AMENDED BY STAFF 1-24-91  
CITY PLANNING COMMISSION  
1231 "I" STREET, SUITE 200, SACRAMENTO, CA 95814

- APPLICATION:**
- A. Negative Declaration
  - B. Tentative Map to subdivide 25± partially developed acres into 87 single family and 36 halfplex lots in the Standard Single Family (R-1) and Rural Estates (RE) zones

**LOCATION:** Rose Street, near Rio Linda Boulevard

**ASCOT ESTATES**

**TENTATIVE SUBDIVISION MAP**

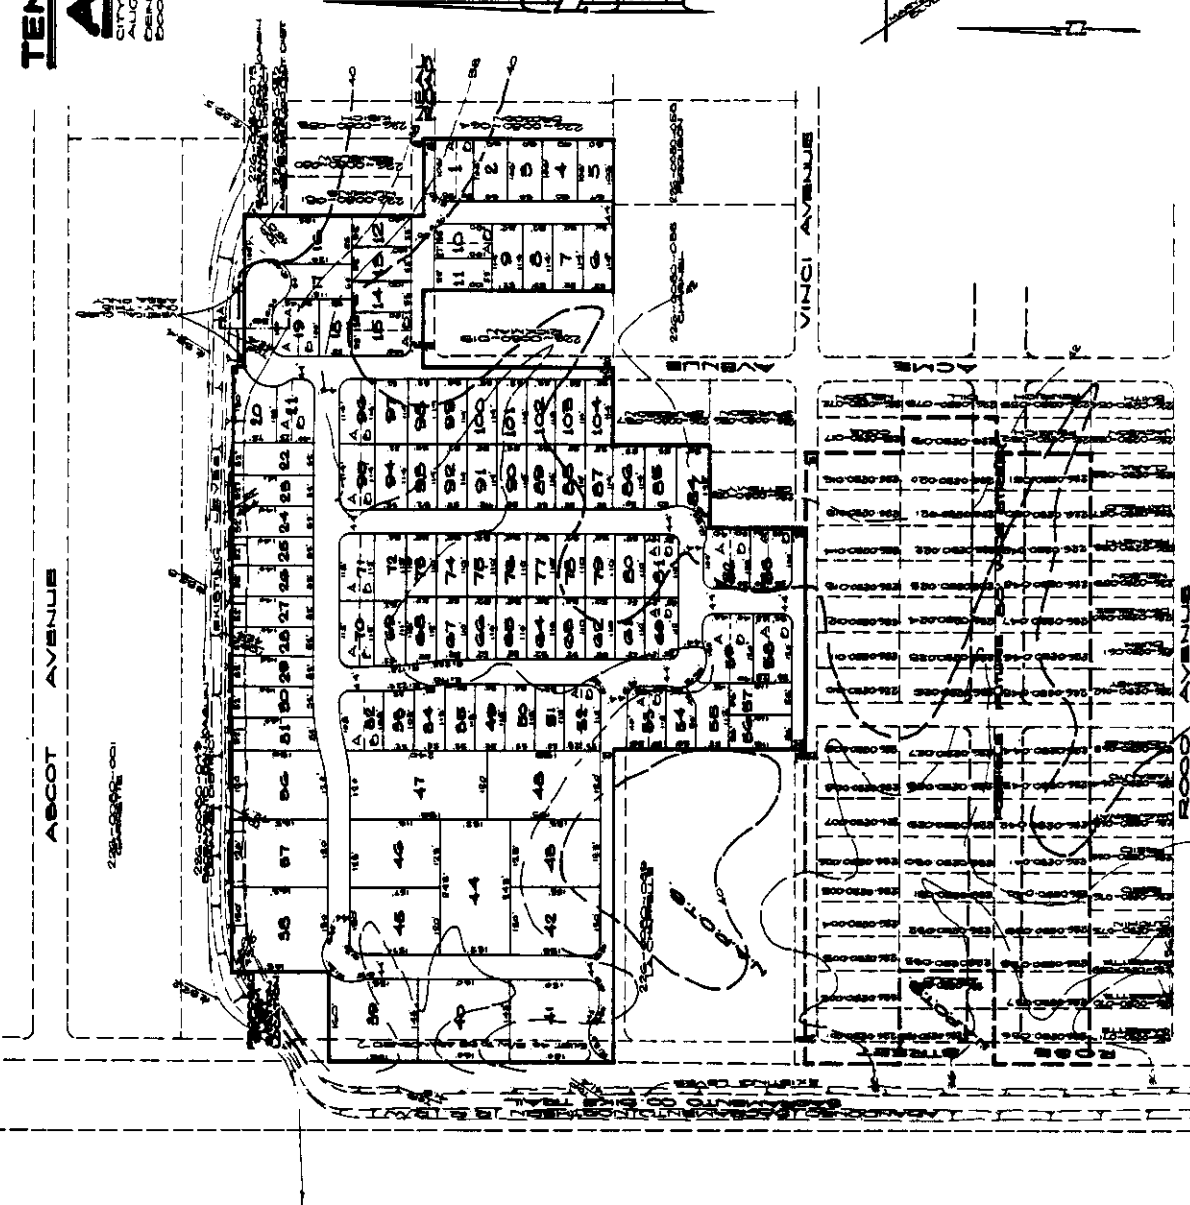
The subject site consists of eleven lots totaling 25± gross acres in the Rural Estates, RE (1 du/.5 na), and Standard Single Family, R-1, zones. The applicant is proposing to subdivide the 6.6± acre portion of the site in the Rural Estates zone into 13 lots with a density of 2 du/na. The applicant is proposing to subdivide the 13.7± acre portion of the subject site in the R-1 zone into 110 lots, including 36 halfplex lots, with a density of 8 du/na. All of the lots in the R-1 zone meet the required minimum standard lot area, width and depth. Each lot in the proposed subdivision must meet the R-1 setback requirements in order to provide adequate yard areas for each lot. The proposed lot configuration provides a logical relationship between the subject site and the existing and future streets. A cul-de-sac at the northeast corner of the site will be available for access to the Magpie Creek drainage canal.

1. Standard street improvements required including a 12 foot paved lane on opposite side of street adjacent to subdivision boundary.
2. Soils testing by a registered engineer for street design will be required.

11. *The following streets should be City standard 50 foot right-of-way streets: Acme Avenue, Vinci Avenue, and Neal Road. (Staff deleted 1-24-91)*
12. Minimum 120 foot offset is required between street adjacent to lots #58 and 59 and street adjacent to lots 60 through 70.

21. *The applicant shall provide a temporary hammerhead to the satisfaction of the Traffic Engineer on the street stub between lots 5 and 6. (Staff added 1-24-91)*

22. *Due to possible negative impacts of the Rio Linda Airport, Lots 36 through 48 will be deleted from this Tentative Map request. (Staff added 1-24-91)*

23. *The applicant shall provide a cul-de-sac at the street stub between lots 31 and 32A to the satisfaction of the Traffic Engineer. (Staff added 1-24-91)*

24. *The applicant shall provide an adequate barrier at the street stub between lots 52 and 53 to the satisfaction of the Traffic Engineer. (Staff added 1-24-91)*
